Title: **Request for consideration to modify glyph and attributes for USAT-04057**

Type: Individual Contribution

Date: 2019/06/08

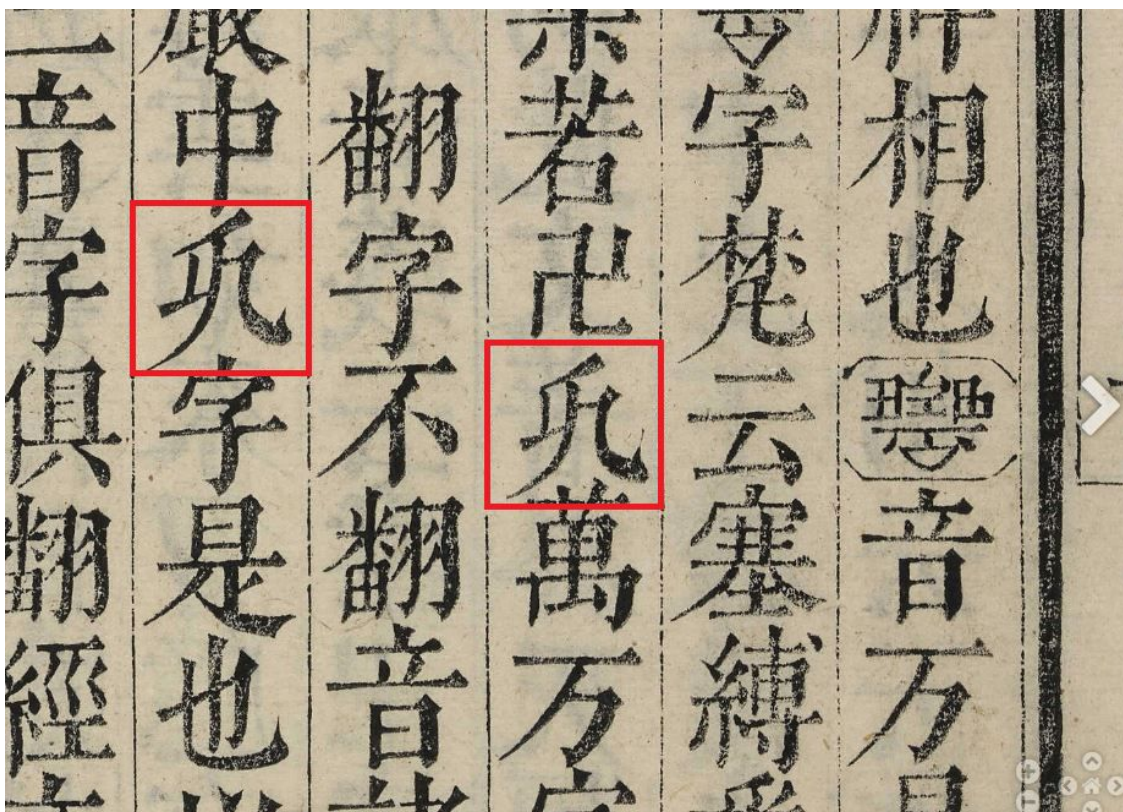
The current glyph in the code charts for U+2D0AA (USAT-04057) is as follows:

However, according to the discussion in <https://github.com/hfhchan/irg/issues/67>, the original source is as follows:

U+2D0AA (USAT-04057) is a variant of 𠄎, and there is a resemblance to 𠄎. However, the current glyph for U+2D0AA (USAT-04057) is quite far from the original evidence, and doesn't resemble 𠄎 at all.

I suggest that the glyph for U+2D0AA (USAT-04057) be modified as follows:

As a result of the glyph change, it is suggested that the Radical be changed to 4 (slash) 丿 and Stroke Count changed to 3.
